ATTACHED ARE THE SLIDES FROM THE “CLINCH RIVER SMR, KEY ASSUMPTIONS” PRESENTATION, WHICH WAS GIVEN AT THE DECEMBER 14, 2010 PUBLIC MEETING WITH TENNESSEE VALLEY AUTHORITY REGARDING KEY ASSUMPTIONS LETTER FOR THE POSSIBLE LICENSING AND CONSTRUCTION OF A SMALL MODULAR REACTOR AT THE CLINCH RIVER SITE (MEETING NOTICE ML103360316)

Clinch River SMR

Key Assumptions
December 14, 2010

First of Class Part 50 Deployment and DCD

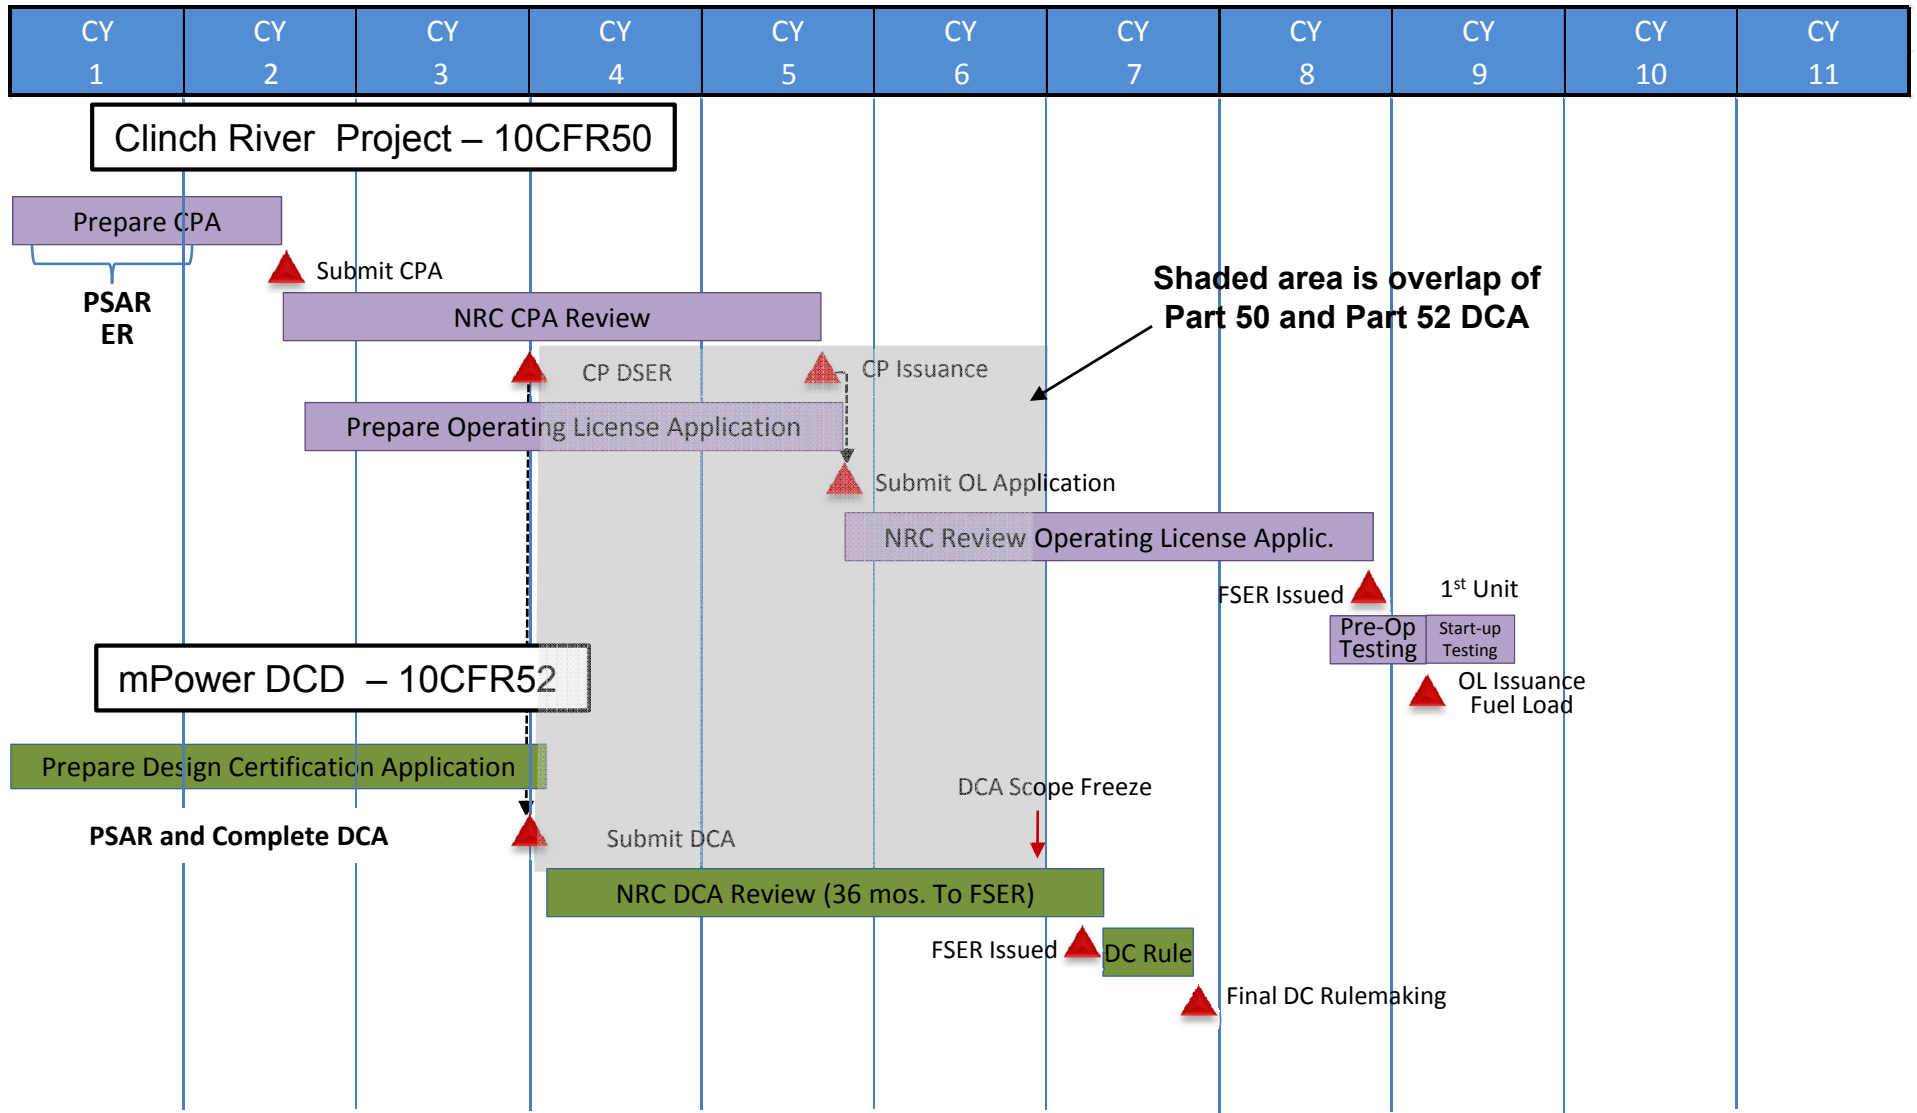
- NRC Question 3 (b):
 - *Clarify TVA's licensing plan using a timeline or schedule including milestones that reflect the submittal plans, review timing, and expectations for concurrent reviews.*
- TVA Intent:
 - See Next Slide

Seismic Example

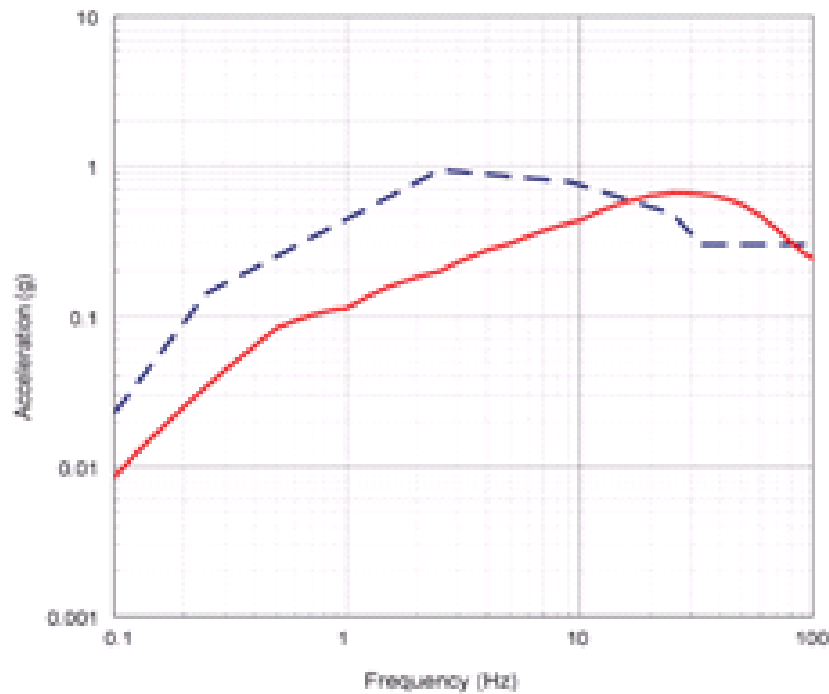
- NRC Question 3 (d):
 - *Assuming two applications, such as an OL- FSAR and a DCR, are being reviewed concurrently, how would TVA and Generation mPower propose to address environmental siting issues, particularly concerning areas where site-specific information is required or bounding parameters and characteristics are required?*
- TVA Intent:
 - CP includes RG 1.70/NUREG 1555 – Clinch River Site Characteristics
 - DCD – Design envelope – RG 1.206 Standard Design
 - OL - RG 1.206 Site Specific
 - OL - Confirmation that site falls within the DCD envelope

•Design CSDRS
•Design Certification Review

—
•Site Ground Motion Response Spectrum
•Construction Permit Review

Operating License Review
•Confirm CSDRS bounds GMRS
•Justify any exceedance if necessary.
